**KENTUCKY-AMERICAN WATER COMPANY**  
**CASE NO. 2021-00376**  
**COMMISSION STAFF'S SECOND REQUEST FOR INFORMATION**

**Witness: Krista E. Citron**

*Typical gate valve diagram*

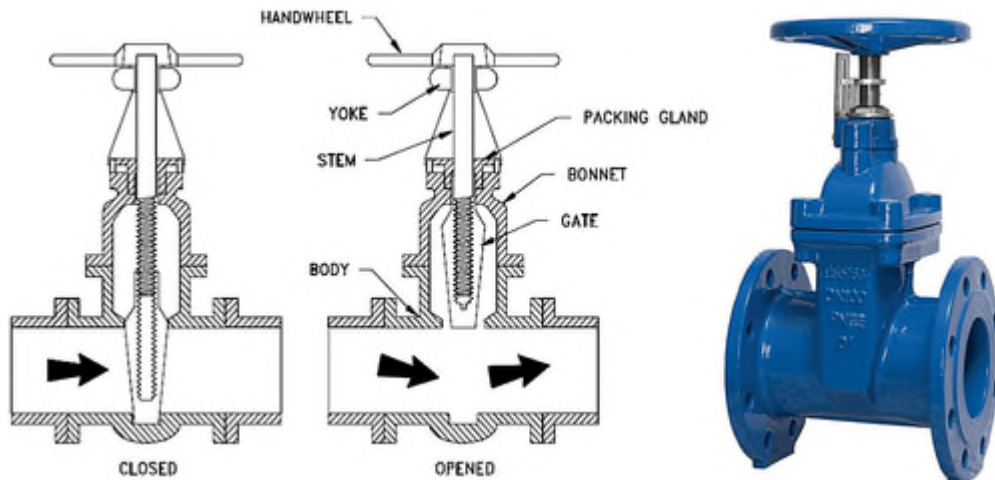
2. Regarding the State Street Phase I and II projects, explain what Kentucky-American meant that the existing valves that were replaced during the two phases were inoperable and explain why the valves were inoperable.

The primary function of a valve on a water main is to control the flow of water through the pipe. When the valve is closed, the water should be isolated to one side. When the valve is opened, water can flow through unimpeded. A fully functional valve can be fully closed with no water leaking past the valve's equipment. However, over time, parts of the valve may wear down or not operate correctly anymore, allowing some water to pass through. Other issues that can occur may include: the valve stem no longer turning well; the valve stem can occasionally break off completely during operation as the torque required to turn the valve apparatus puts a large amount of force on the stem; bolts can shear and the valve housing can separate; and, the operating nut or handwheel can break or strip so that it cannot be turned until it is replaced. Yearly inspections on large valves, while important and necessary, also put wear and tear on the stems and valves.

The result of any of these occurrences is that the valve is no longer fully controlling the flow of water through the pipe. In order for main replacements or other work to take place, the water must be shut off. If valves are closed to isolate a section of main but water continues to leak out, work cannot continue. On larger diameter pipes this can mean a large quantity of water.
